# AXC F 2152 – CHANGE NOTES

## Change notes for the AXC F 2152 controller

Application note  
108427\_en\_18

This document contains all changes made between firmware version 1.0.0 and the current firmware version of the AXC F 2152 controller (Order No. 2404267).

Figure 2 Select Trigger task

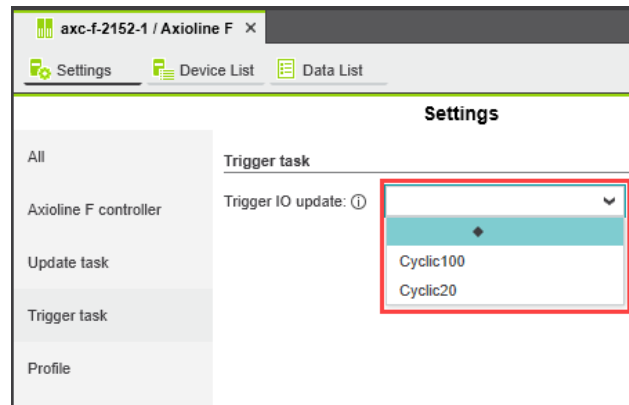
You can now specify the refresh interval for Axioline F I/O data. This is done by selecting which task triggers the Axioline F I/O data update in the PLCnext Engineer project.

- Double-click on the “Axioline F (x)” node in the “PLANT” area.

- Select the “Trigger task” view in the “Settings” editor.
- In the drop-down list, select the task that is to trigger the Axioline F I/O data update.

If you do not select a task, the update will occur by default every 50 ms.
